## **Item 1 - Information Report, LPAB, May 9, 2016**

### **5000 Piedmont Avenue. Mountain View Cemetery** **Planning File:REV130001. Design Modifications to the Water Pavilion.**

**Project Name: Water Pavilion - Resubmittal**

2 PROPOSED SOUTH-EAST ELEVATION  
 3/64"=1'-0" @ 11X17    3/32"=1'-0" @ 24X36

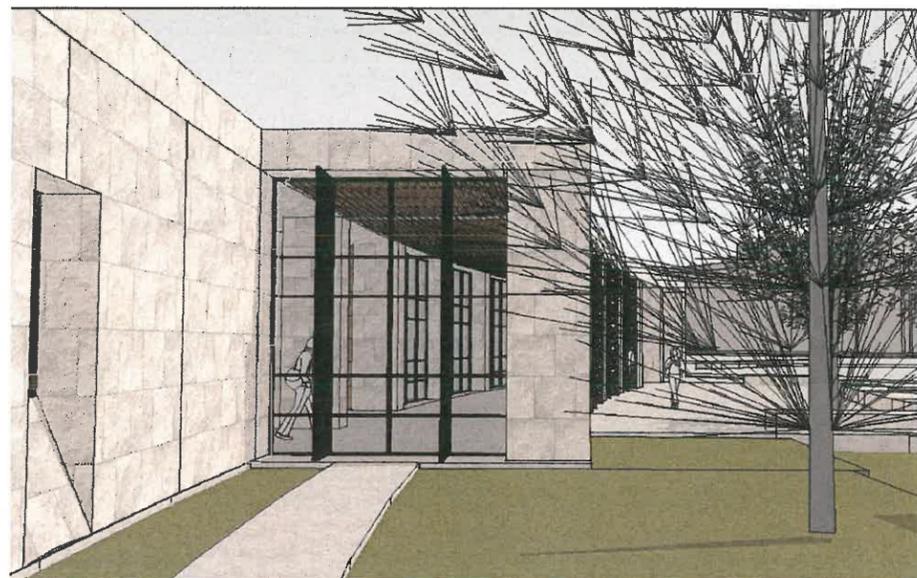
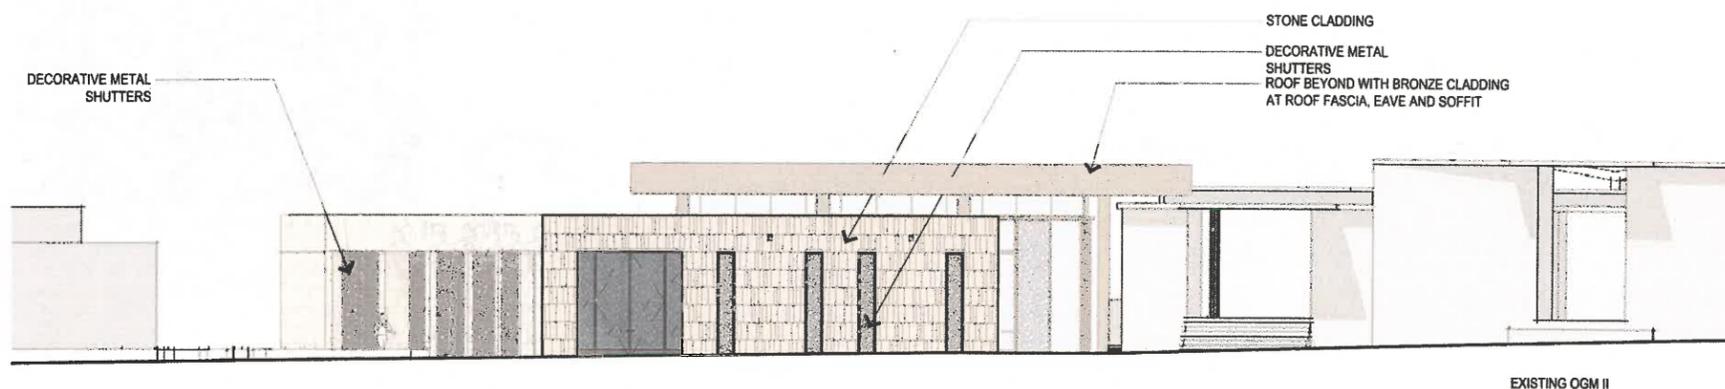
- Key changes:
- \* Significant inflation between original budget preparation and actual commercial stone quotes requires value engineering
  - \* Options include a) reducing the size module of stone and randomizing the pattern to reduce cost yet maintain visual interest, or b) cladding with a high quality stucco
  - \* A smaller stone module solves a potential problem with larger pieces of flat stone making an unintended faceted look to the curvilinear building and a smaller module fixes that problem
  - \* A high quality stucco could yield the textural appeal of the original plan and solve the visual problem of a faceted facade
  - \* If a smaller stone module is adopted, stone tiles at doorways will be mechanically affixed for safety and will allow for selected use of larger pieces of stone

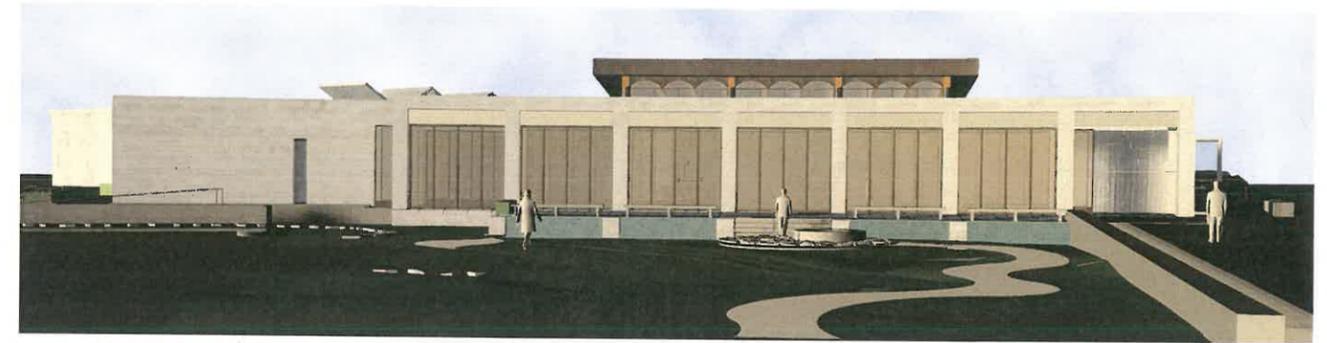
- New Elements:**
- \* Gas fire seating area as focal point, accessible
  - \* Curvilinear shape for sculpture or ornamental trees
  - \* Water fall to garden theme to north east pond theme
  - \* Garden as its own destination

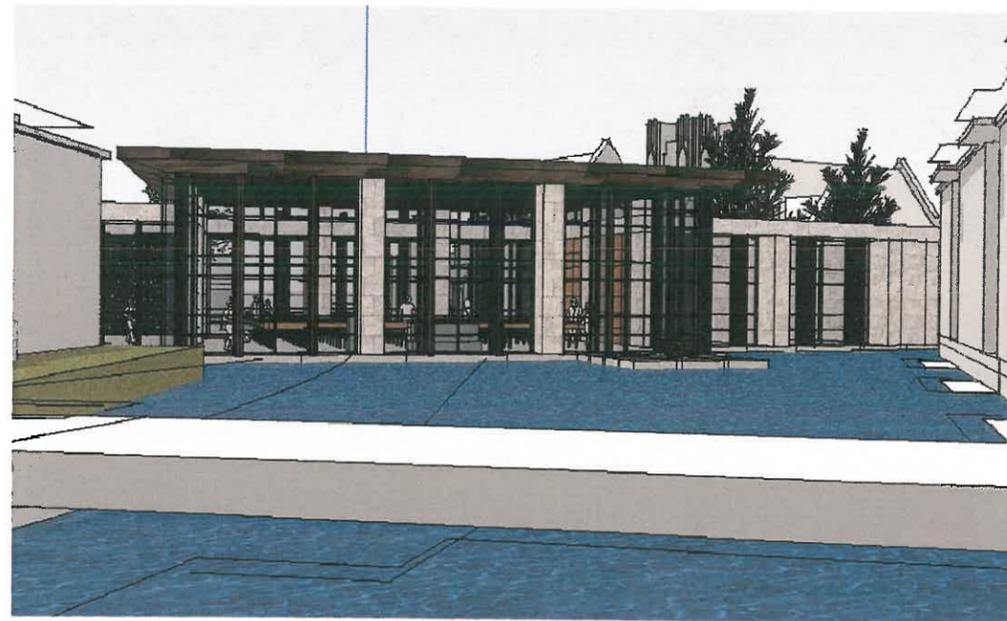
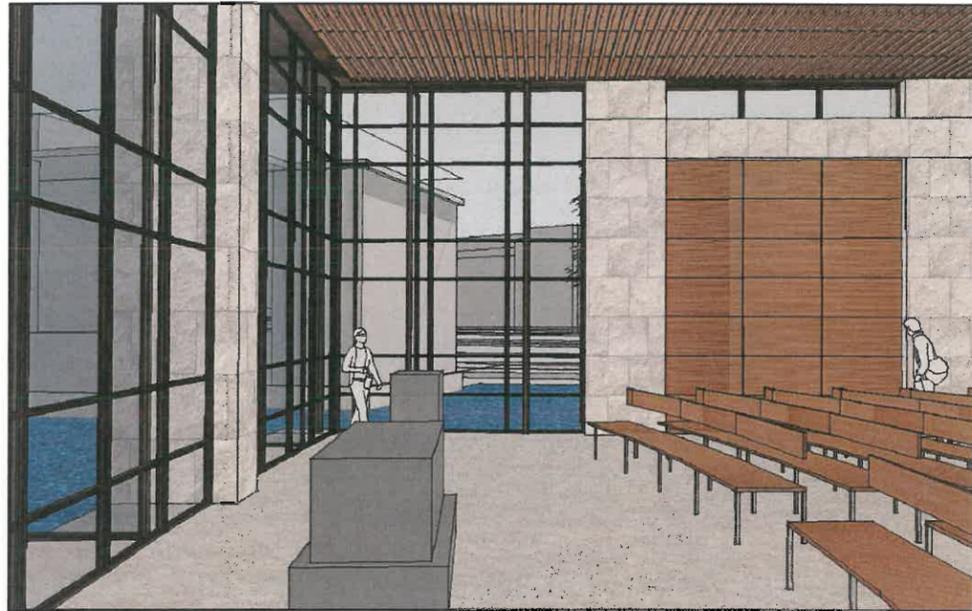
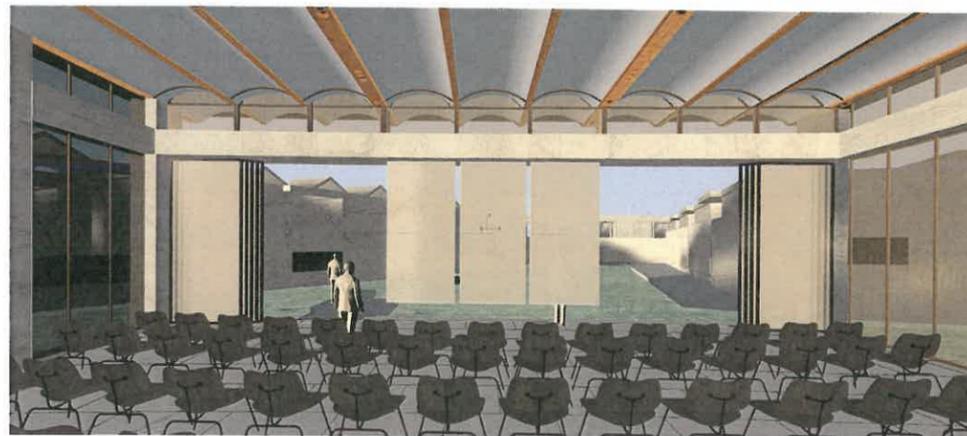
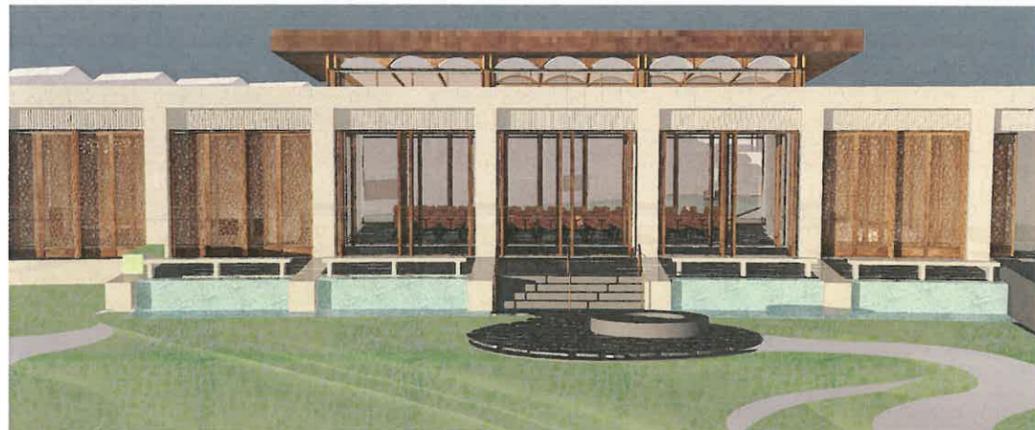
- \* The 2016 plan reviews door and window operation for closer code compliance
- \* Energy code at 2016 will require evaluating whether the southwest decorative metal screens need to be replaced with something, such as wood shutters, that will provide more shade. The complexity resides with making the screens operable to maintain views.
- \* Multiple suppliers declined to manufacture screens citing weight, maintenance and safety
- \* Curtains or shades are proposed for the pond side to maximize the potential indoor/outdoor guest experience
- \* Curtains or shades, when door(s) are open will add a feeling of movement from a breeze
- \* Decoupling metal screens from windows or doors at the pond side enables a cinematic pond perspective
- \* In light of cost and metals theft the modified plan gives consideration to lighter non-precious metals while yet retains the intended bronze look

**PROPOSED SOUTH-WEST ELEVATION**

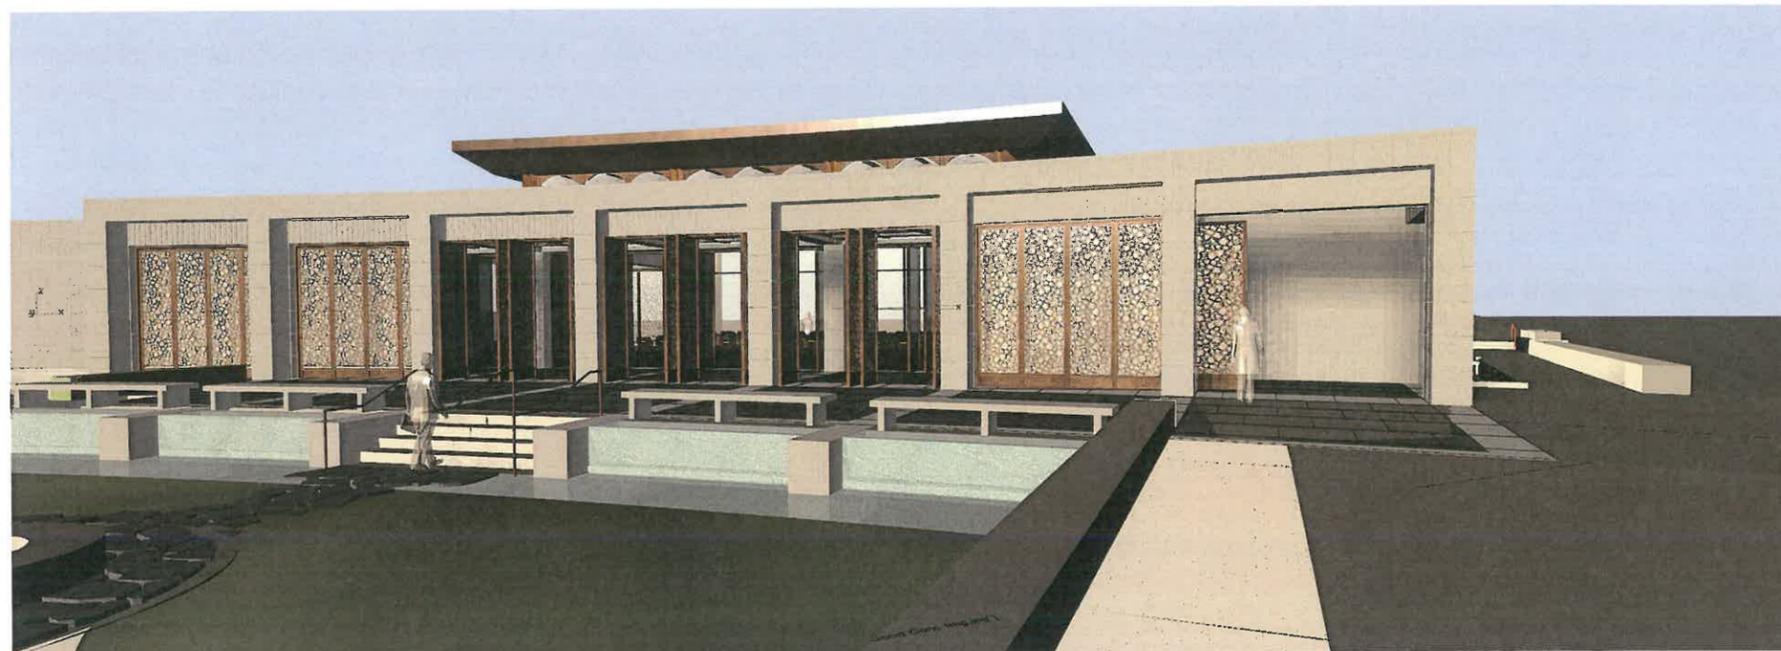
- Key changes:
- \* Addition of a 2' deep mechanical, electrical, plumbing and fire plenum to meet applicable ventilation and other codes
  - \* Addition of barrel vaults to the chapel ceiling for aesthetic purposes of form and lightness, but also to provide space and channels for ventilation and air-conditioning (barre vaults also add visual interest both day and evening)
  - \* Adds air-conditioning in response to computer modeling suggesting air-conditioning is required to maintain a reasonable level of temperature and humidity
